UL upgrade from UL 498 to UL 60320-1.

Product Change Notification					2573 Change of marking		
owner	creation date	release date	released by	change order no	rev	page	D10-055-680
zeierjo	31.03.2021	31.03.2021	muehlema	2021025	B	1 of 2

Old product rating and approval	New product rating and approval
<p>Terminals in orientation A</p> <p>Front side</p>  <p>Back side</p> 	<p>Terminals in orientation A</p> <p>Front side</p>  <p>Back side</p>

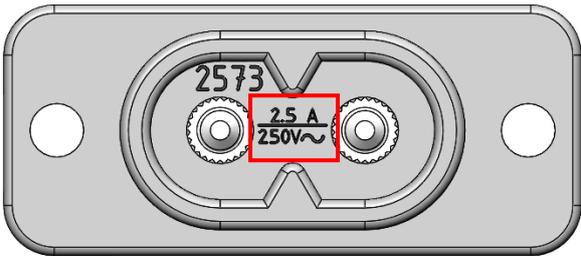
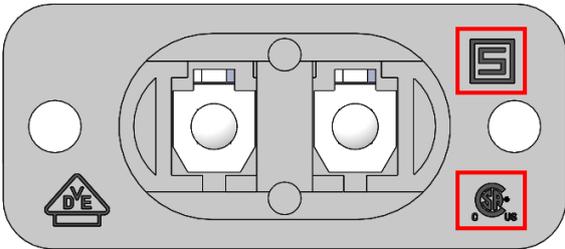
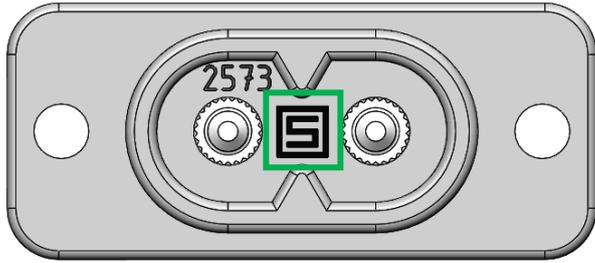
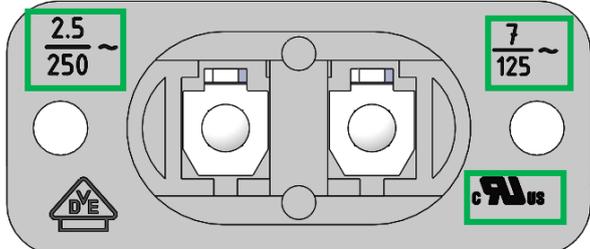
Marking for UL rating 7A/125V~ added. Marking for IEC rating 2.5A/250V~ updated. CSA / UR Approval Mark replaced by cURus.
